Upgrade to 4 Bedrooms 2.0

IREDELL COUNTY HEALTH DEPARTMENT

IMPROVEMENT PERMIT / AUTHORIZATION TO CONSTRUCT / OPERATION PERMIT / EXISTING SYSTEM

INITIAL SITE SKETCH

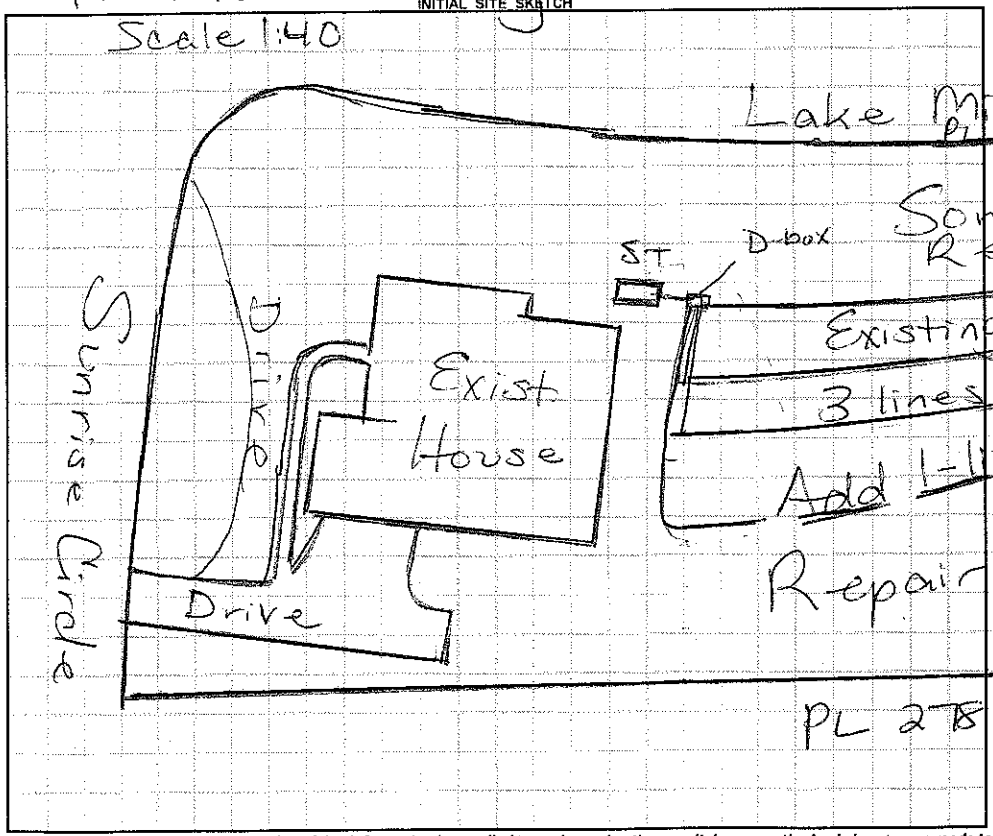
★ Remove Water line/gutter drain? That is crossing over drainfield.

★ Direct Storm/Surface Water away from Septic System. Must keep Septic Drainfield 15ft (Sitegradient) from Storm drain. Water lines must be 10ft from Septic

Installed Q4, remove drain over drainfield.
